# Historic Resources Board

## Staff Report (ID # 14036)

**Summary Title:** 567 Hale (Tobey House)

**Title:** PUBLIC HEARING: 567 Hale Street [21BLD-02531]: Request for Historic Resources Board Review of a Building Permit Application for Consistency with the Secretary of the Interior's Standards. The Project Includes Exterior Modifications to a Local Historic Resource Category II. Zone District: R-1 (10,000). Environmental Assessment: Exempt from the California Environmental Quality Act per Sections 15268 (Ministerial Projects). For More Information Contact the Project Planner Danielle Condit at [danielle.condit@cityofpaloalto.org](mailto:danielle.condit@cityofpaloalto.org).

FRONT  
EXTERIOR ELEVATIONS

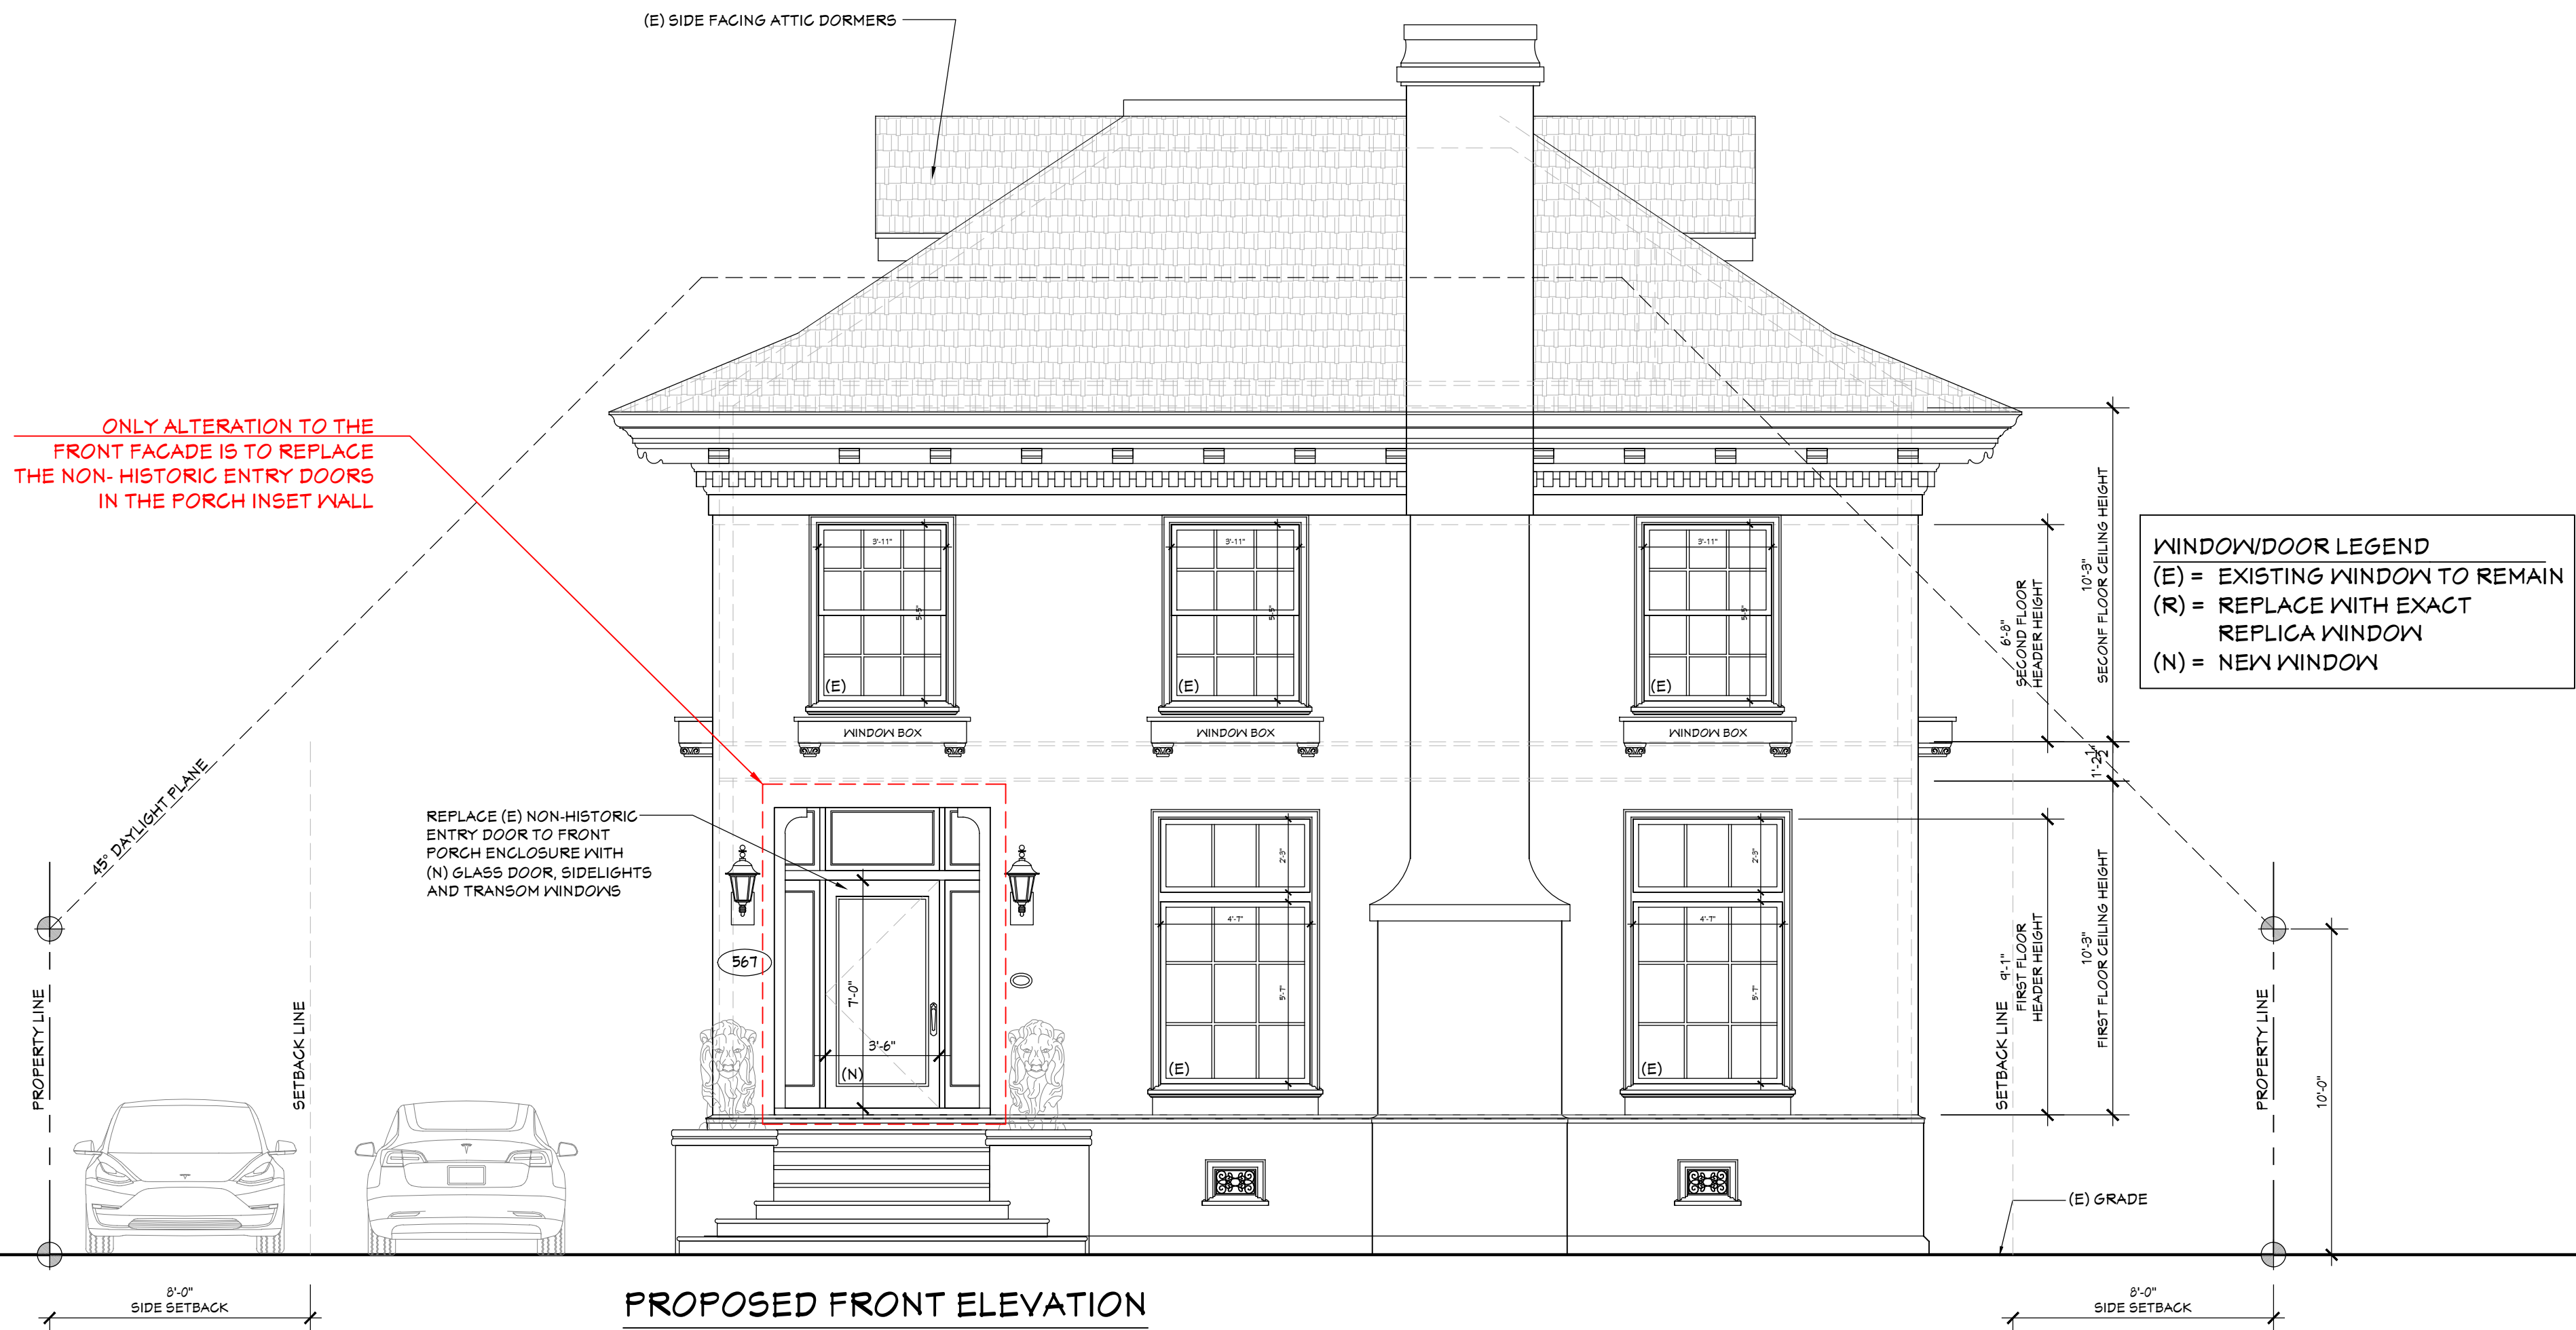
Although windows at the second story are apparently not original, the openings that windows are set within are original, and are typically arranged to provide vertical alignment between the first- and second-story openings and a very balanced composition from façade to façade. Fenestration with a balanced, generally even spacing, and with divided-lite glazing was a common aspect of Classical Revival style residences of the early twentieth century, and in the case of the Tobey House, a key aspect of Bliss & Faville's design of the residence. The proposed window alterations would result in a shift away from the building's formal fenestration, as it would introduce windows in new openings that are not consistently vertically aligned between stories and are of varying dimensions and glazing patterns that do not harmonize with the building's historic character. The enlargement of the rear patio entrance to fit glazed doors would on its own not significantly impact the balanced fenestration of the rear façade. However, combined with proposed second-story window alterations, these changes affect the historic character of the facade.

**Recommendation #1 (Standards 2, 5, 6, 9):** Revise the proposed design to retain more of the historic window openings (size, shape, and location) and avoid removal of historic windows that contribute to the character of the property. Prioritize retention of historic wood windows at the first story of each façade that have divided-lite glazing. Retention of a greater number of historic wood windows and a greater number of existing window locations would result in less substantial alteration of the building's historic fenestration and support its Classical Revival style character that dates to the 1904 period of significance.

Recommendation	Design Revision	Revision Meets SOI Standards (Yes/No)
<b>Recommendation #1 (addresses SOI Standards 2, 5, 6, 9)</b>		
<p>Revise the proposed design to retain more of the historic window openings (size, shape, and location) and avoid removal of historic windows that contribute to the character of the property. Prioritize retention of historic wood windows at the first story of each façade that have divided-lite glazing. Retention of a greater number of historic wood windows and a greater number of existing window locations would result in less substantial alteration of the building's historic fenestration and support its Classical Revival style character that dates to the 1904 period of significance.</p>	<p>As revised, the proposed project retains most existing window locations and the dimensions of such openings. Although all of the remaining original single-glazed wood windows will be replaced, plans note that such windows will be replaced with replica double-glazed windows with identical glazing patterns. These changes result in the continued use of divided-lite windows, and support the house's Classical Revival styling, which relies on a balanced and somewhat formal fenestration pattern.</p>	<p>Yes</p>

PROPOSED INTERIOR SIDE (NORTH WEST) ELEVATION  
scale: 1/4"=1'-0"

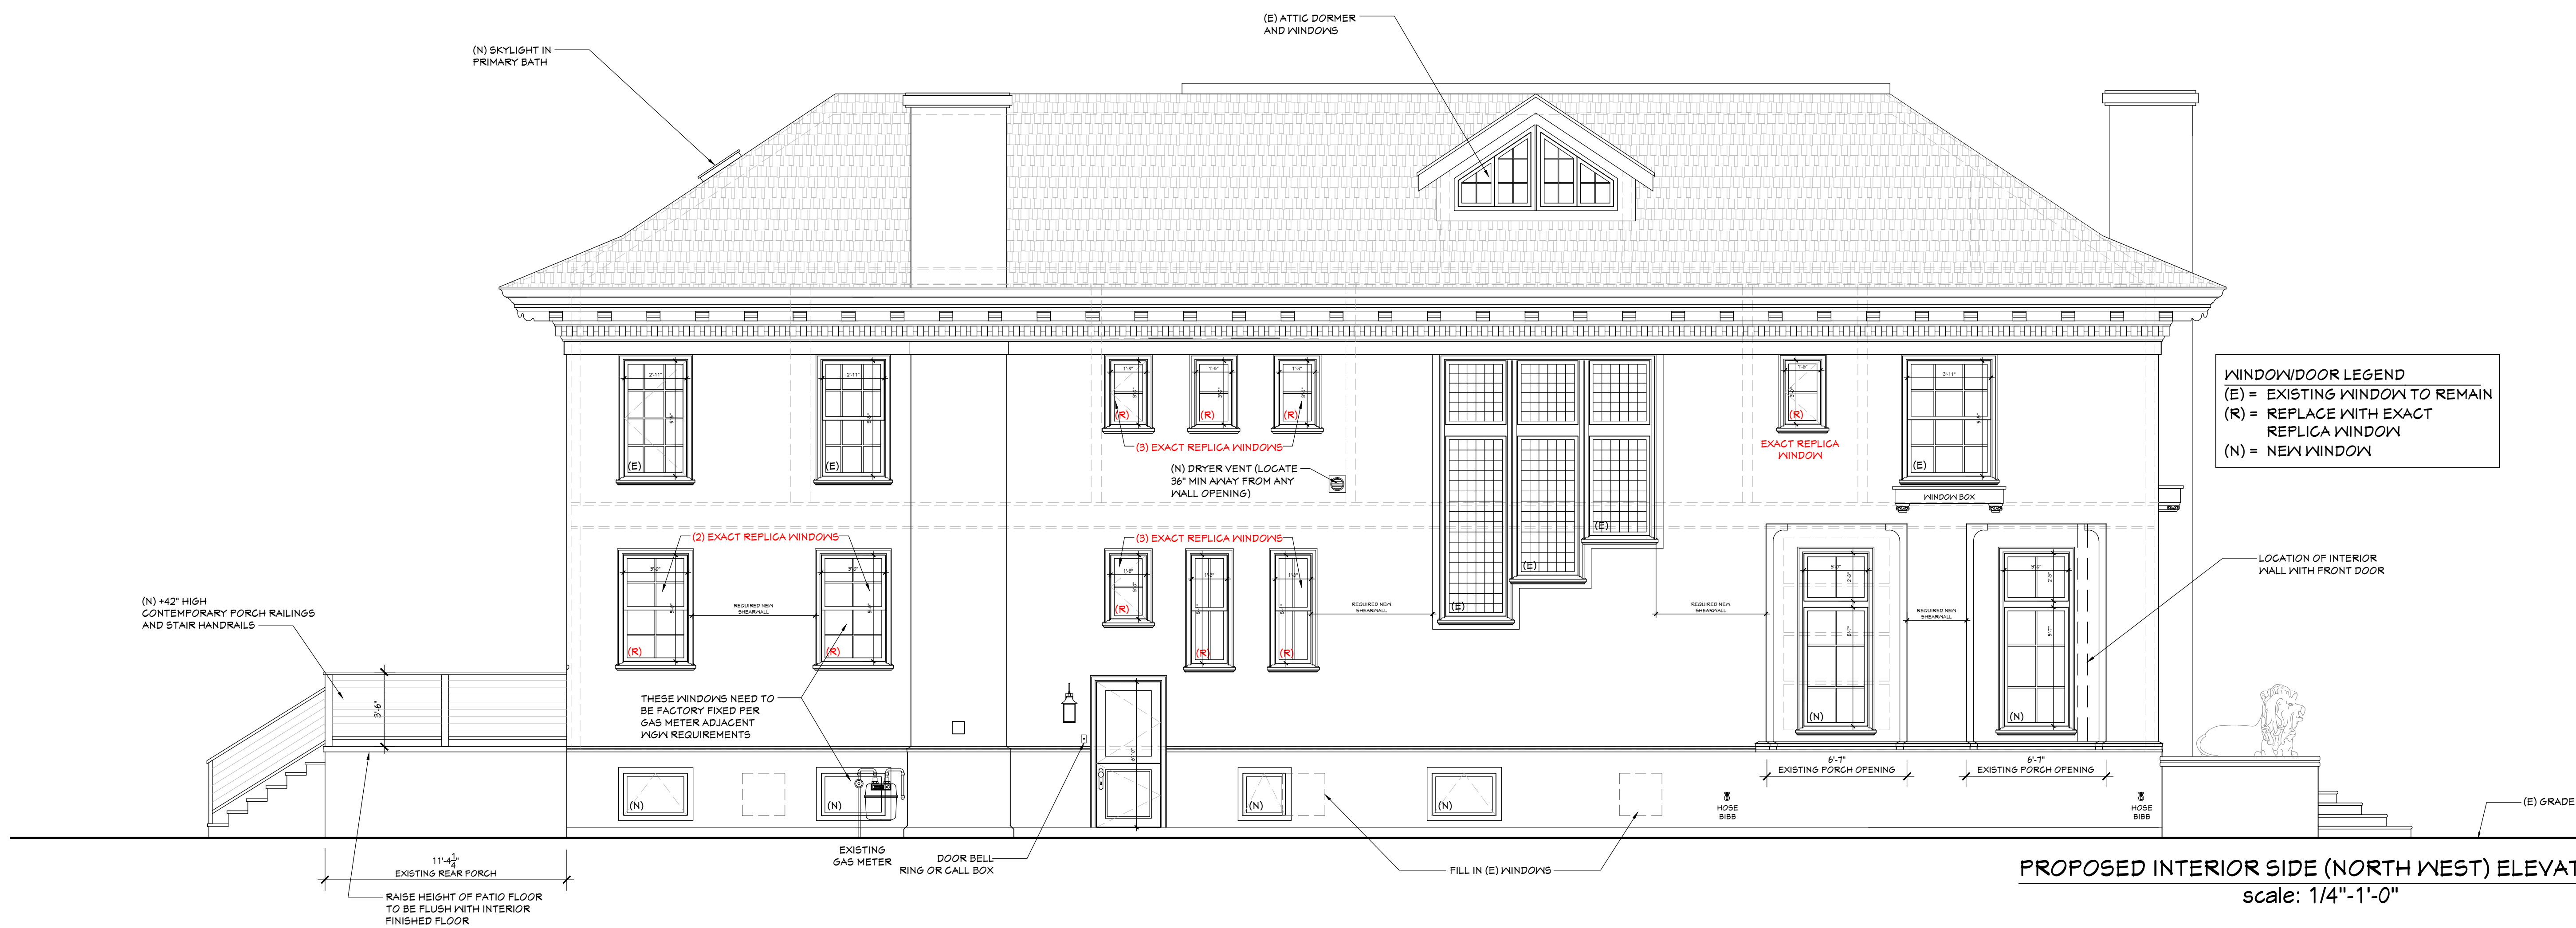
However, as previously described, the project proposes replacement, infill, relocation, and insertion of window openings to provide new windows with single- or two-lite glazing. These exterior alterations as a whole diminish the building's ability to convey its significance as a Category 2 building designed in the Classical Revival style by Bliss & Faville. The proposed project would leave only the windows at the primary façade, two windows at the front (southernmost) end of the side façades, and one window at the rear façade intact. Thus, fenestration patterns that characterize the residence would be altered heavily on three of the four façades. New windows would be clearly differentiated from the old, given their obvious differences in number of lites per sash, and in some locations new windows would be oriented with a horizontal rather than a vertical emphasis. Although differentiated, the new windows would not be very compatible, as their positions and relationship to historic windows retained elsewhere would not result in a similar balanced fenestration pattern along each façade. The contrast of the single-lite windows to the divided-lite windows would also be too strong to comply with Standard 9. The existing divided-lite windows, although not original, provide a more compatible alternative.

<b>Recommendation #2 (addresses SOI Standard 10):</b>		
<p>Consider locating some of the new single-lite windows at the second story in existing openings and using divided-lite windows, which would support future reversibility more than locating new windows in new openings and provide a more compatible glazing pattern to the house's historic windows with divided lites. Slightly different muntin profiles and lite dimensions are acceptable and aid in differentiating new windows from old.</p>	<p>The revised design follows this recommendation. as a greater number of original openings will be retained. The new windows replacing single-glazed windows will feature identical glazing patterns. Overall, the retention of original window openings supports reversibility and compatibility of historic and new construction. Therefore, the project follows this recommendation.</p>	<p>Yes</p>

PROPOSED INTERIOR SIDE (SOUTH EAST) ELEVATION  
scale: 1/4"=1'-0"

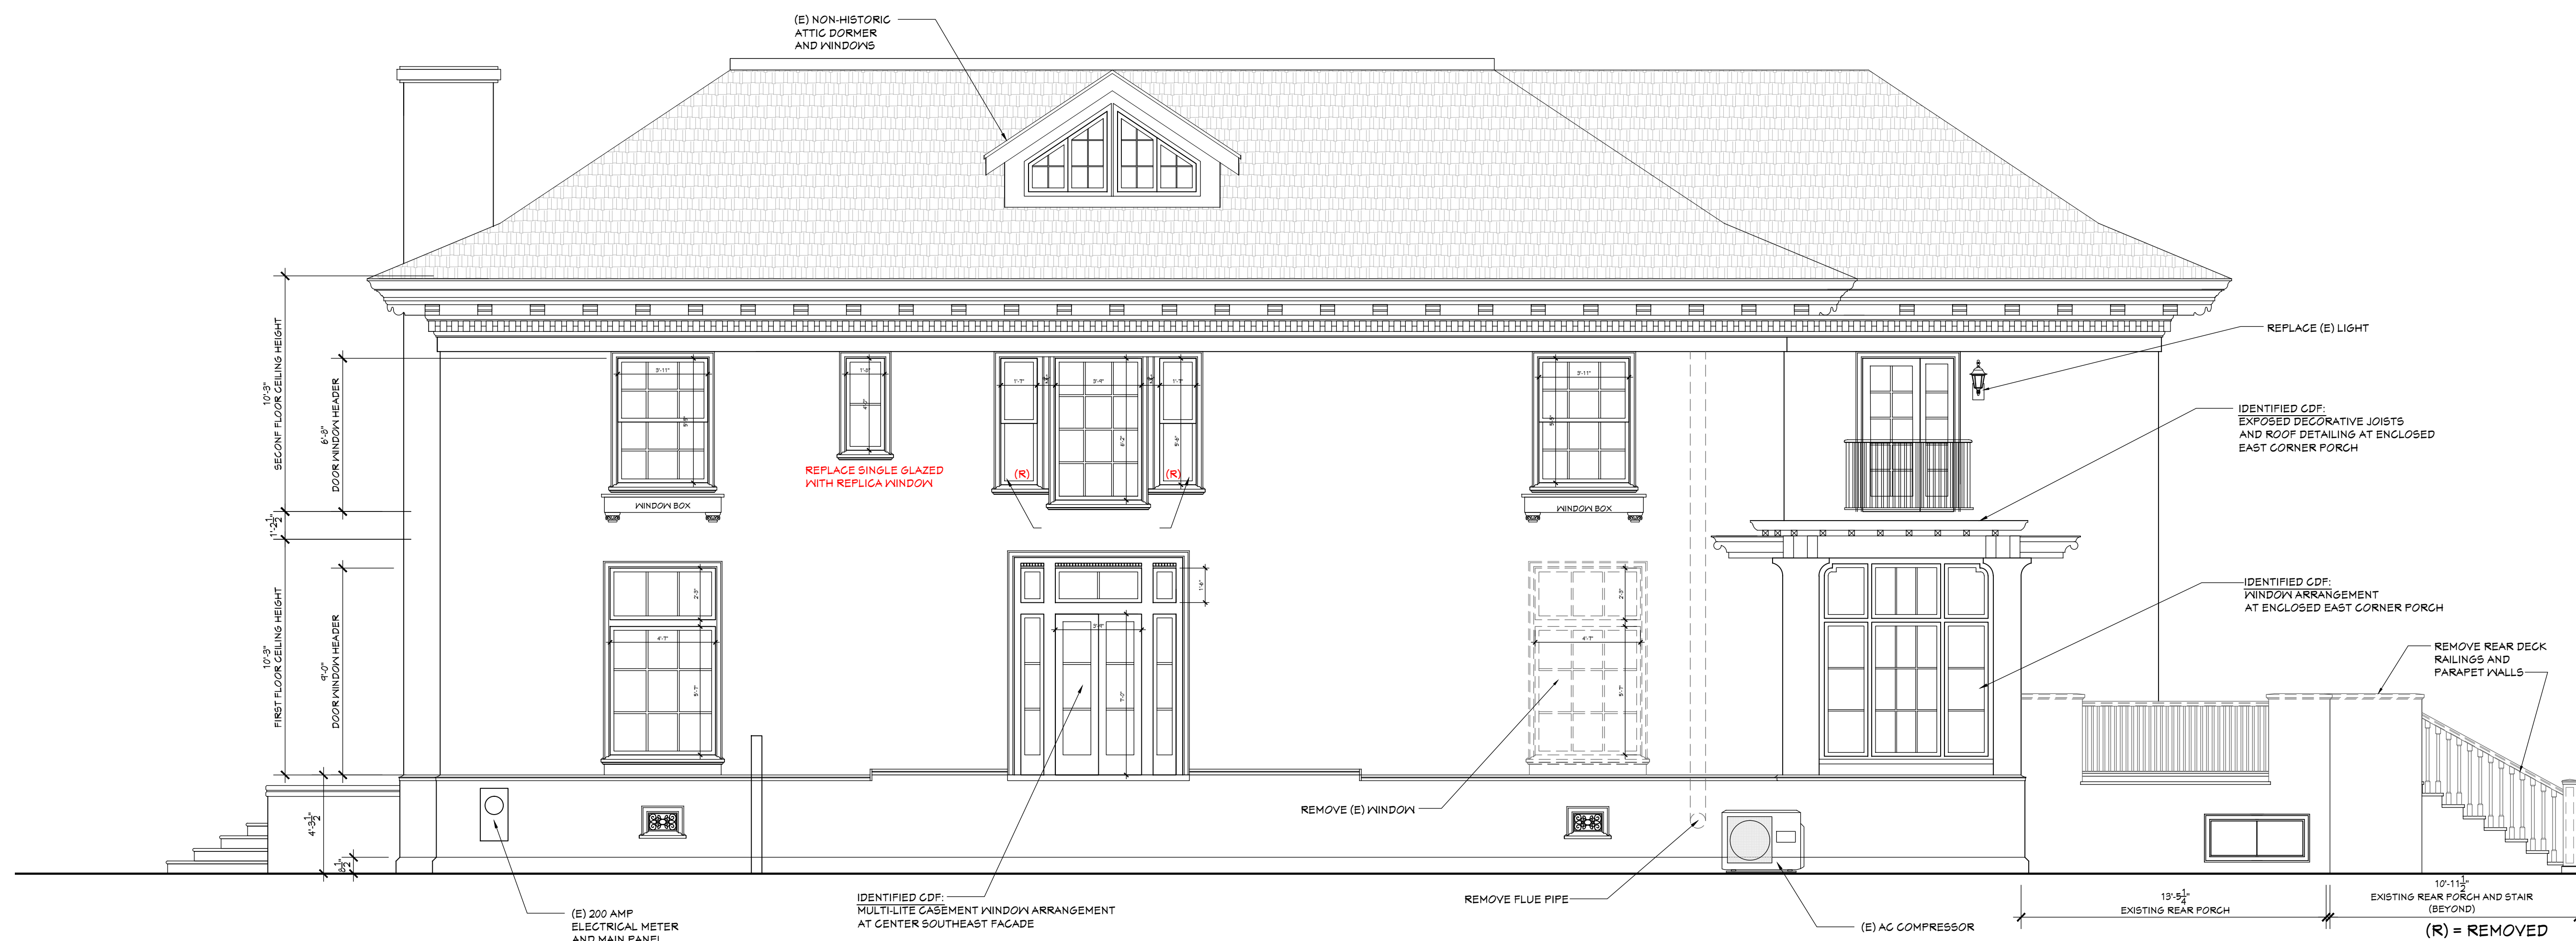
The proposed project would introduce new windows on each side façade, relocate one window on the southeast façade, and would redesign the rear façade. Review of project plans indicates that new wall sections would be built to accommodate infilling and relocation of windows. Although a future project could attempt to reverse such changes, it is likely that doing so would result in further loss of historic materials, and historic windows previously removed would (unless salvaged and stored) be unable to be reintroduced. Although the project would preserve the building's massing, height, footprint, and materiality, its integrity would nonetheless be diminished to the extent that it could not be regained. Overall, the project does not comply with Rehabilitation Standard 10.
